**CITY OF PORTLAND, MAINE
DEVELOPMENT REVIEW APPLICATION
PLANNING DEPARTMENT PROCESSING FORM
Planning Copy**

Neptune Aircraft Hanger
Project Name/Description

RE: 1111 Westbrook Street, Neptune Aircraft Hangar
CBL: 199 A001

**1111 Westbrook Street, Neptune Properties Hangar Project
Sidewalk and Curb waiver review comments by criteria.**

TO: ERIC LABELLE
FROM: MIKE SCARKS
RE: HANGER SEWER CONNECTION

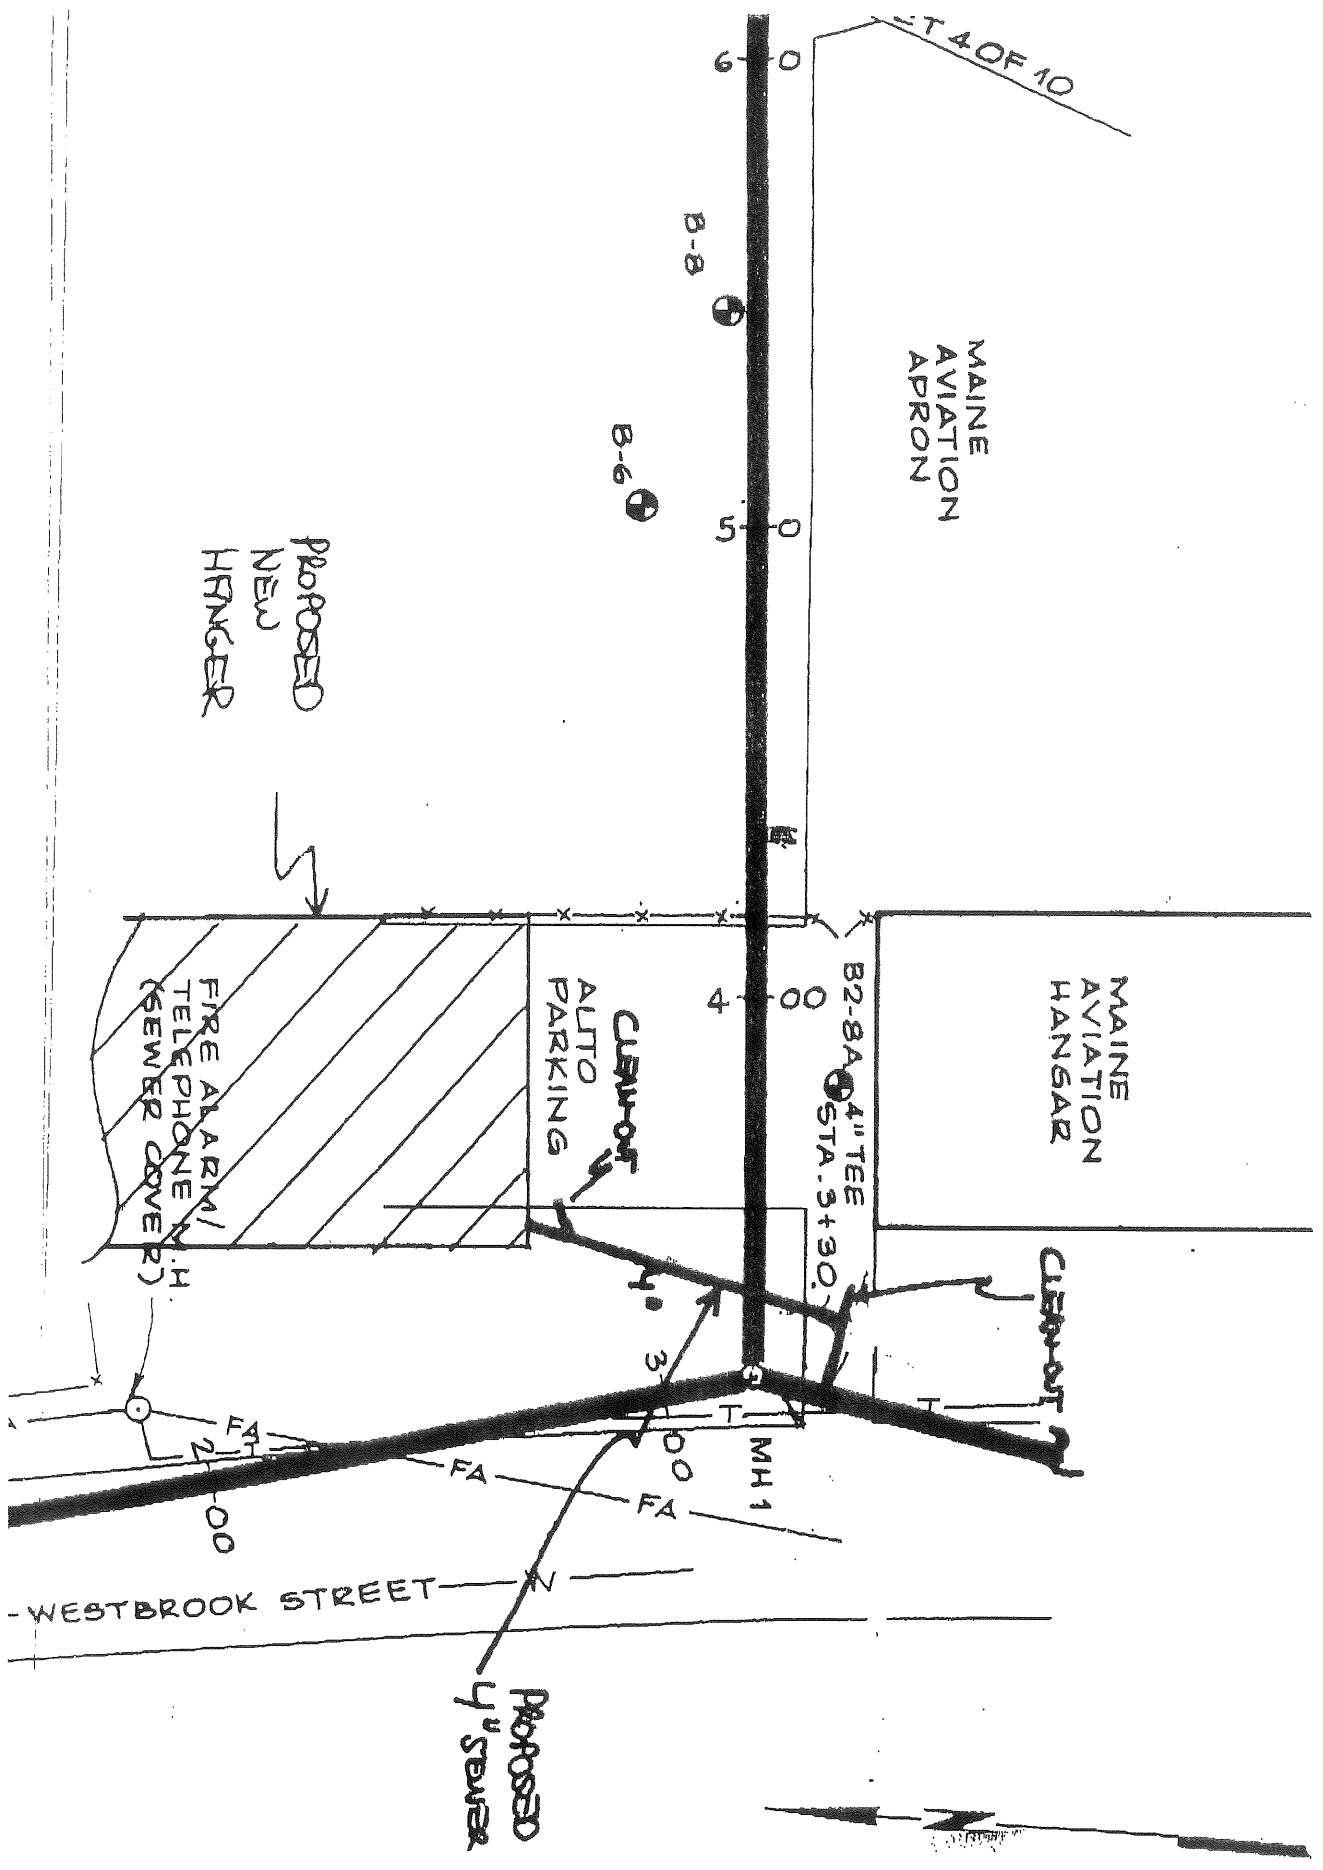
ERIC: TO FOLLOW-UP ON OUR PHONE CONVERSATION OF LAST FRIDAY (8/11)
I MET WITH DAVE PETERSON AT YOUR SUGGESTION TO DISCUSS THE
SEWER CONNECTION FOR MY NEW HANGER AT 1111 WESTBROOK ST.

AFTER CHECKING IN THE FIELD THERE IS AN EXISTING 8" DROP
INLET INTO THE MANHOLE IN QUESTION, AND ALTHOUGH THE INSET
OF THE MANHOLE IS 20'+ DEEP THE 8" PIPE PRIOR TO THE DROP
IS ONLY 7'+ BELOW GRADE. DAVE AND I DISCUSSED HOW TO
CONNECT TO THIS PIPE AND I SAID I'D FOLLOW-UP WITH A
SKETCH. THAT PLAN IS ATTACHED HERE AS 8 1/2 X 11 PORTION OF
THE FULL-SIZE SEWER PLAN I PROVIDED TO DAVE DONE BY
DUFRESNE-HENRY. IF THIS IS OK WITH YOU PLEASE CALL BILL NEEDLEMAN
SO HE'S OK WITH IT. I ALSO AM LOOKING FOR A "CAPACITY LETTER" FROM
FRANK BRANCEY. I RAN INTO FRANK WHILE AT PUBLIC WORKS THIS TUESDAY,
SO MAYBE YOU COULD GIVE BILL THE OK ON THAT ALSO IF FRANK IS DOING
HIS WORK. CALL IF YOU HAVE ANY QUESTIONS.

CE8 Series

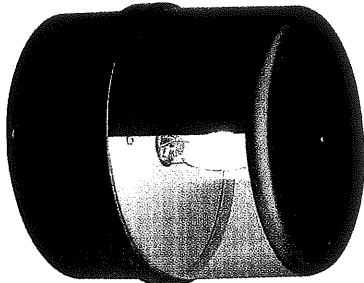
- The four building mounted lighting fixtures on the westerly (Westbrook Street) side of the building, labeled "CE8" on the lighting schedule, be revised to provide full "cut off" shielding; and,
- The seven remaining building mounted lights, labeled "CF" on the lighting schedule, be mounted at a zero degree angle of tilt so as to achieve full "cut off" shielding.

Revised lighting fixture and mounting details shall be submitted for Planning Authority review and approval prior to installation.
